Landscape Plan

4250 HANCOCK EXPRESSWAY

Parcel: 6502002015

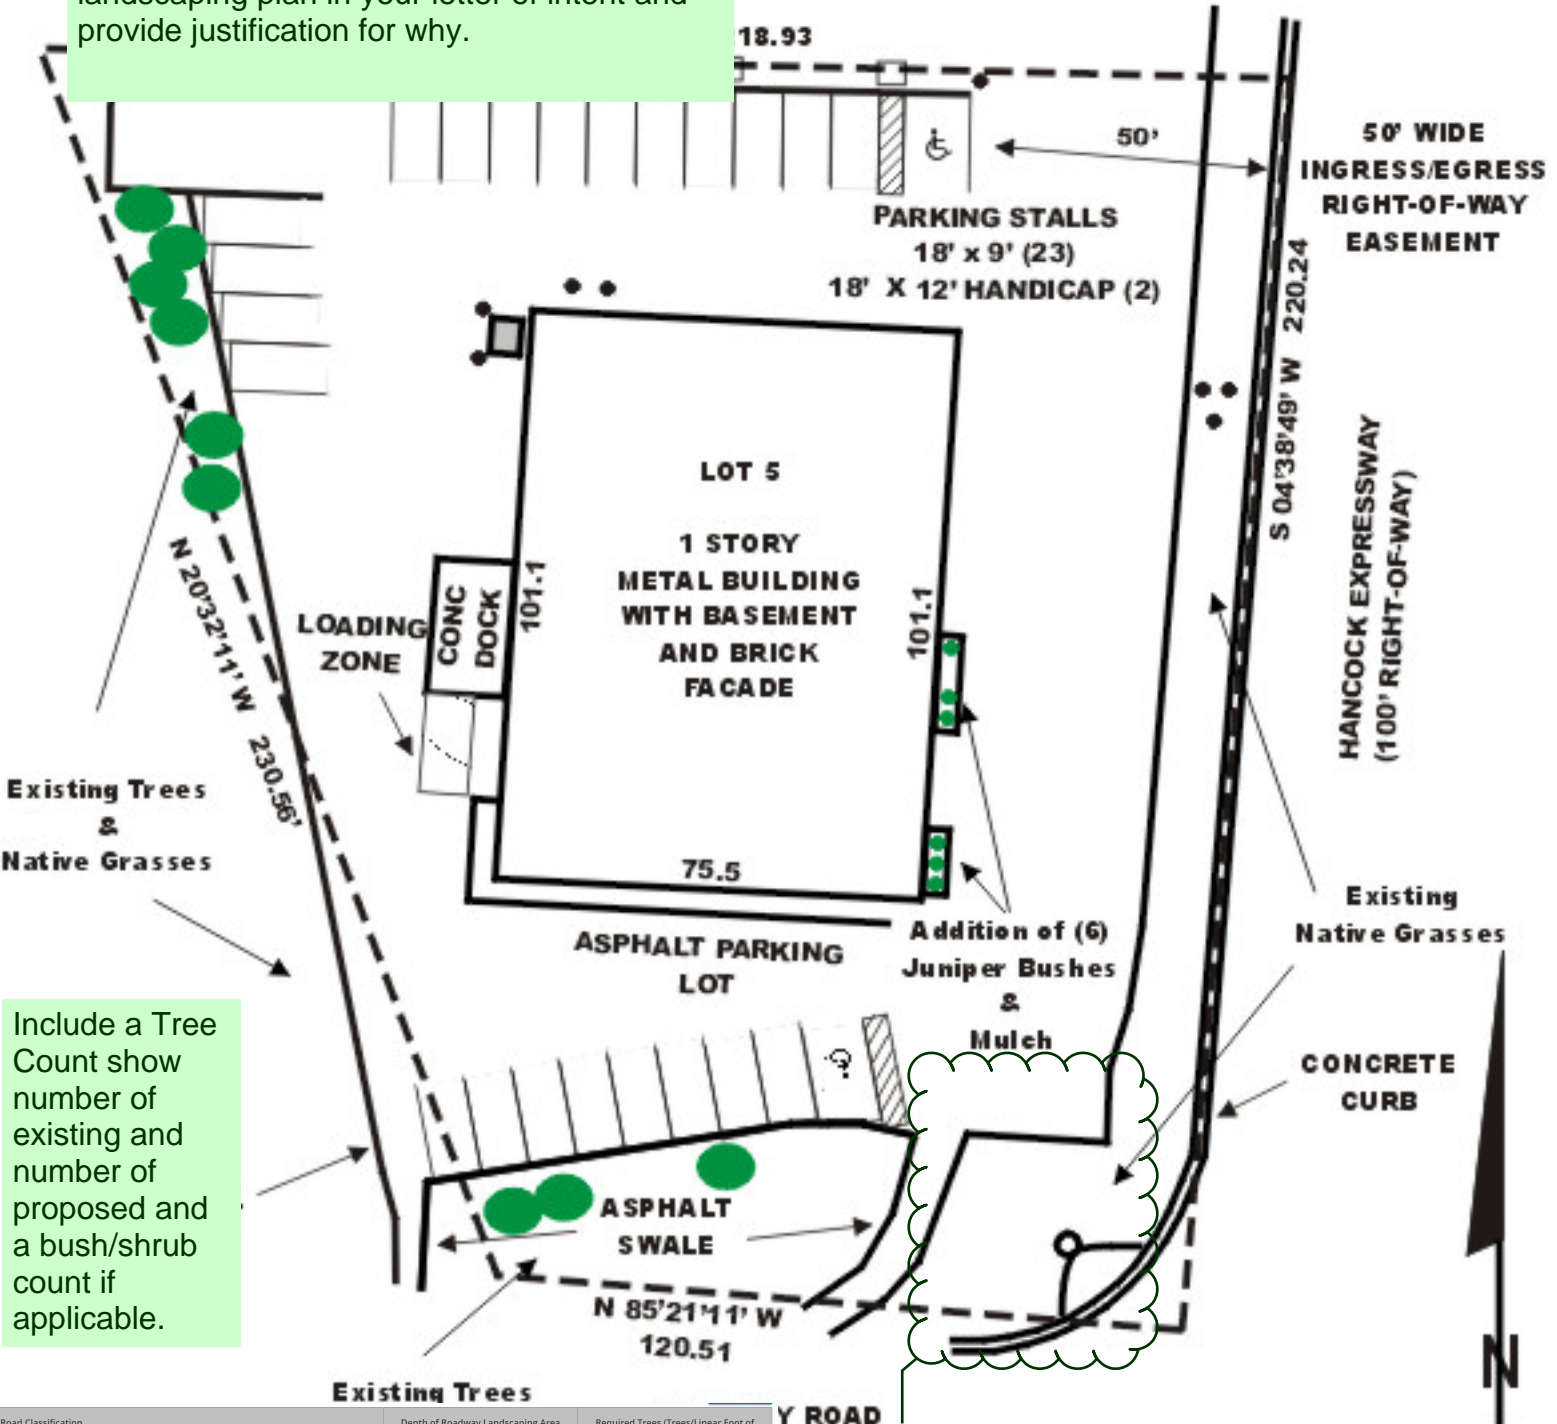
6.2.2.(B) Roadway Landscaping Requirements. Roadway landscaping areas are required. A roadway landscaping area is located along the lot, parcel or tract frontage between the road right-of-way, easement, or tract boundary lines and any building or use.

please read chapter 6.2 of the land development code and either redo landscape plan accordingly or request an alternative landscaping plan in your letter of intent and provide justification for why.

Include a Tree Count showing number of existing and number of proposed and a bush/shrub count if applicable.

Show the width of landscaped roadway buffer areas.
